Access Compliance Report

Public Rights-of-Way

(Curb Ramps)

Intersection ID: 3494	Main Street: REAMES_RD	Cross Street: W_W_T_HARRIS_BV	Location: SE
ADA ID: DEE1BFC594B0	Ramp Type: Perp	Initial Pass/Fail: Fail	Overall Compliance: No
Severity Score: 30			
Codes/Mitigation Info/Possible Solution		Field Measurements/Component Compliance

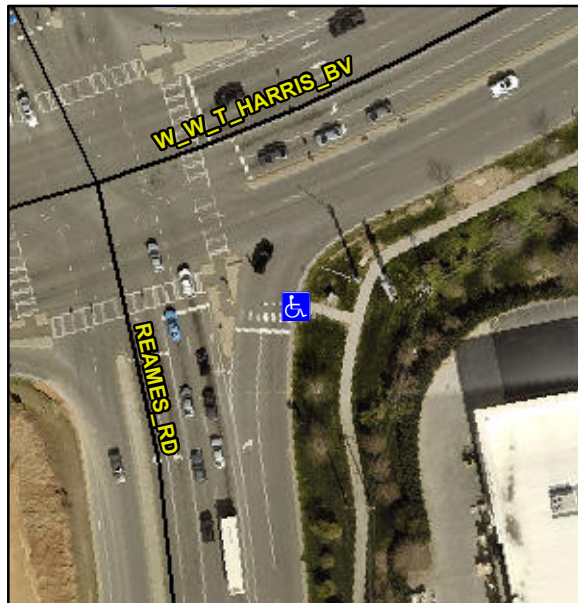
Not Found, R304.5.1, R304.2.2

Compliance	Description	Data	Compliance	Description	Data
N/A	Ramp Length (in)	63.0	No	Ramp Slope (%)	11.4
No	Ramp Width (in)	35.0	Yes	Ramp XSlope (%)	1.0
N/A	Flare Type LT	N/A	N/A	Flare Type RT	N/A
N/A	Flare Slope LT (%)	N/A	N/A	Flare Slope RT (%)	N/A
N/A	Flare Traversable LT?	N/A	N/A	Flare Traversable RT?	N/A
N/A	Landing Length (in)	N/A	N/A	DWS Provided?	N/A
N/A	Landing Width (in)	N/A	N/A	DWS Contrast?	N/A
N/A	Landing Slope (%)	N/A	N/A	DWS Length (in)	N/A
N/A	Landing X Slope (%)	N/A	N/A	DWS Full Width?	N/A
N/A	Landing Curb? (Y/N)	N/A	N/A	DWS Offset (in)	N/A
N/A	Shared Landing?	N/A			
N/A	Gutter Ponding?	N/A	N/A	Gutter Slope (%)	N/A
N/A	Gutter Lip Ht (in)	N/A	N/A	Gutter X Slope (%)	N/A
N/A	Painted X Walk1?	Yes	N/A	Painted X Walk2?	N/A
	X Walk 1 Direction	To NW		X Walk 2 Direction	N/A
N/A	X Walk 1 Width (in)	117.0	N/A	X Walk 2 Width (in)	N/A
	X Walk 1 Slope (%)	2.0		X Walk 2 Slope (%)	N/A
	X Walk 1 X Slope (%)	2.1		X Walk 2 X Slope (%)	N/A

Remove & Replace Entire Ramp.
